Subject: **Docket Nos. 50-361 and 50-362**
Amendment to SONGS Units 2 and 3 NPDES Permits
San Onofre Nuclear Generating Station Units 2 and 3

ADDENDUM NO. 1 FOR SAN ONOFRE NUCLEAR GENERATING STATION, UNIT NOS. 2 AND 3, ORDER NO. 99-47 AND 99-48, NPDES PERMIT NOS. CA0108073 AND CA0108181.

ADDENDUM NO. 1

ORDER NO. 99-47 AND 99-48
NPDES NO. CA0108073 AND CA0108181

ATTACHMENT 1 Water Quality Station Locations

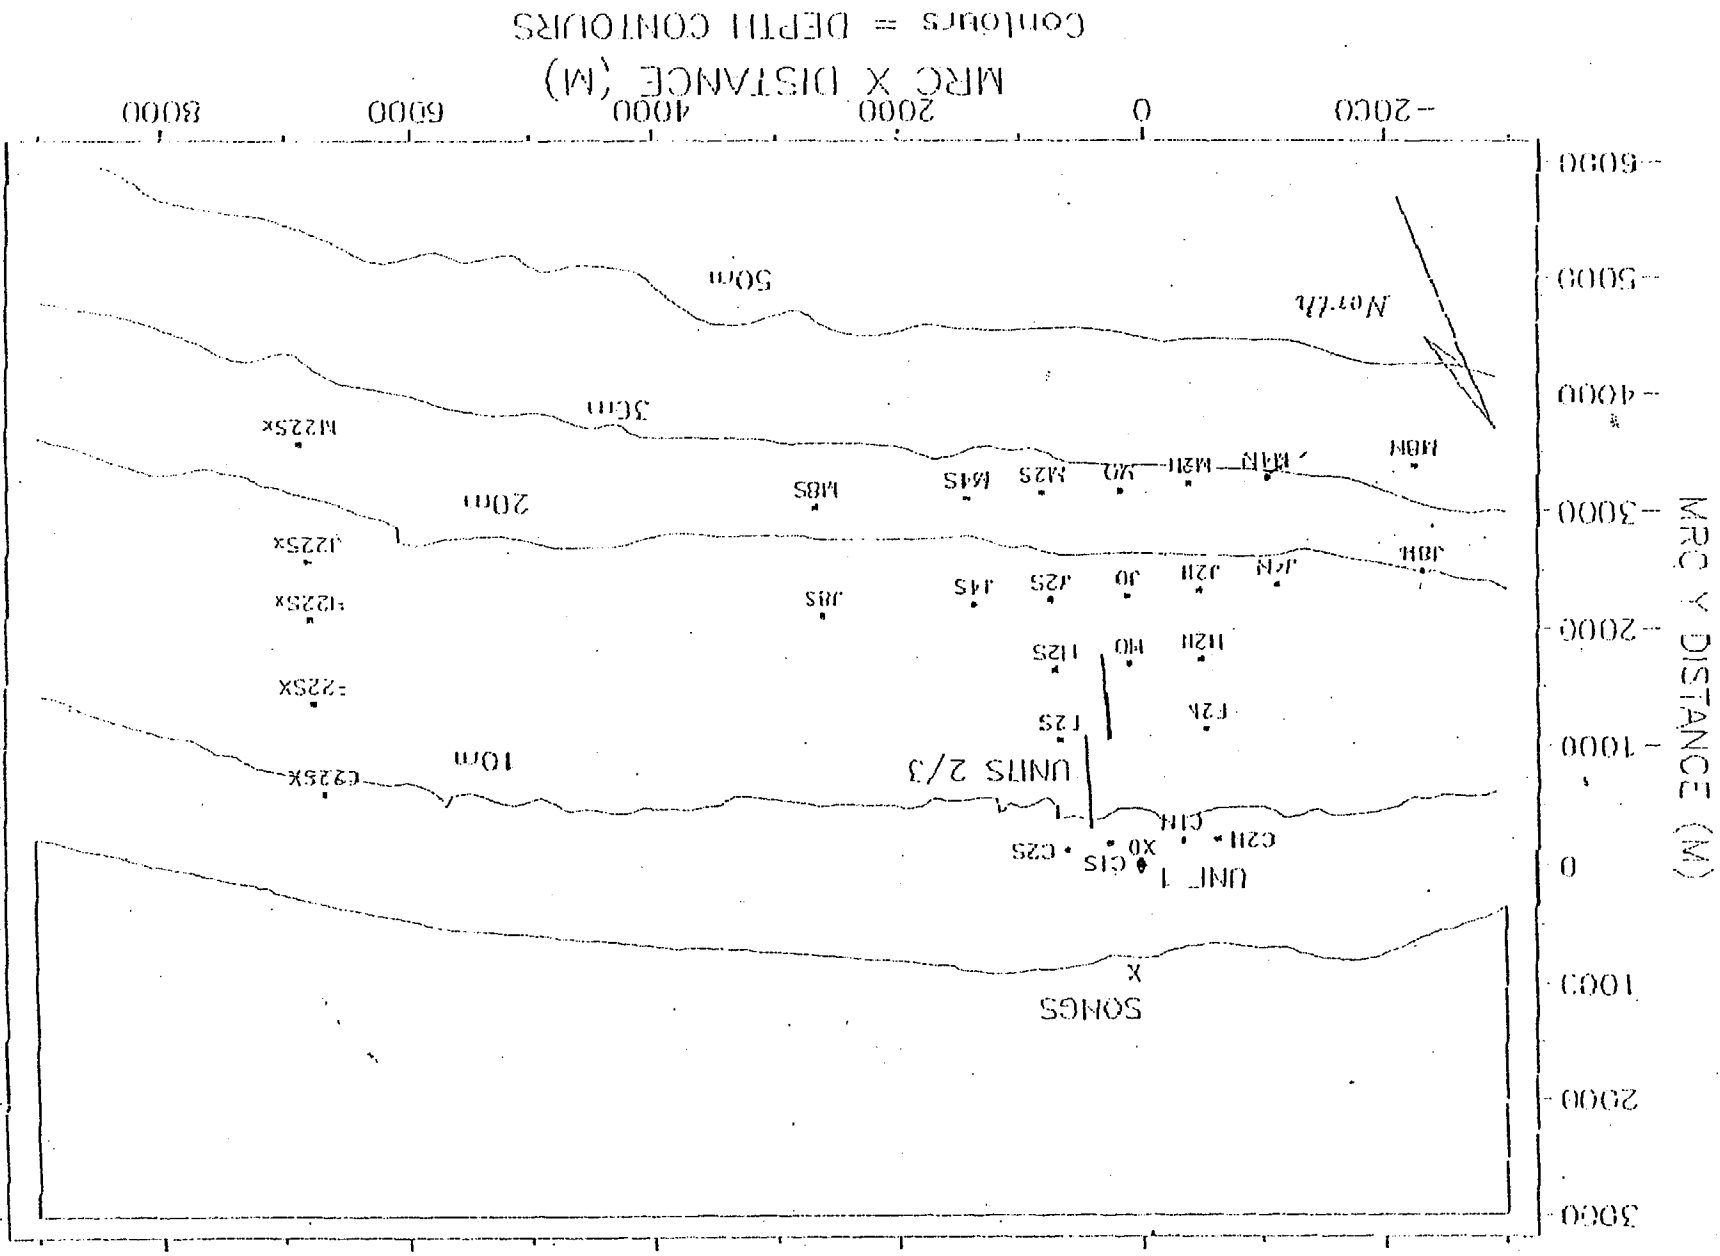
A. Add additional control stations H22S, J22S, and M22S and remove stations F24S, F26S, and F20S for temperature and transmissometer profiles (Attachment 1).

ATTACHMENT 2 Coliform Monitoring Stations

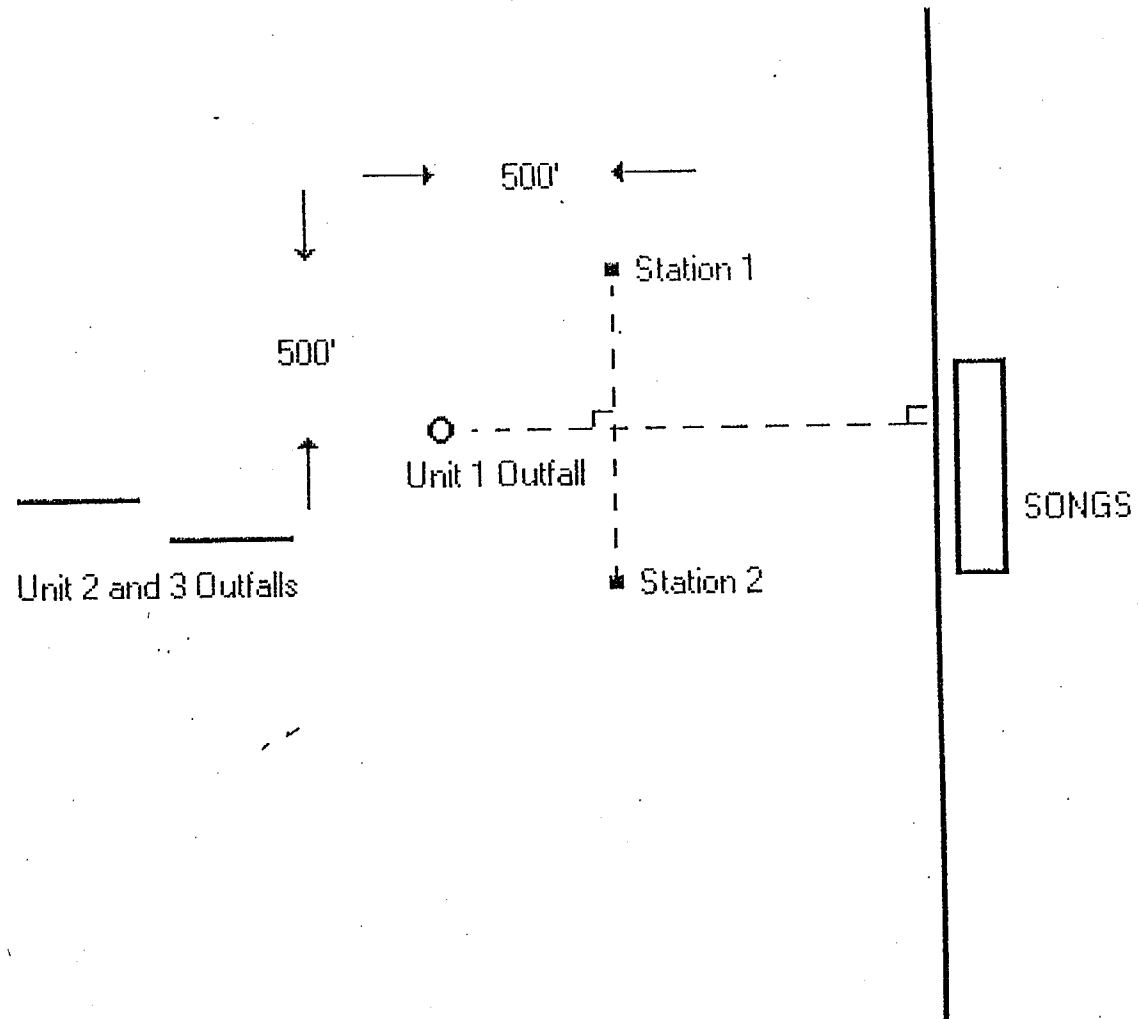
Monthly grab sampling shall occur at two locations shown in Attachment 2. The two locations shall be located 500 feet shoreward of the Unit 1 Outfall. Station one shall be located 500 feet upcoast and the station two shall be located 500 feet downcoast. Samples shall be taken from surface, mid-depth, and bottom and be analyzed for total coliform density, fecal coliform density, and enterococcus density. Results shall be reported in units of number of organisms per/100ml.
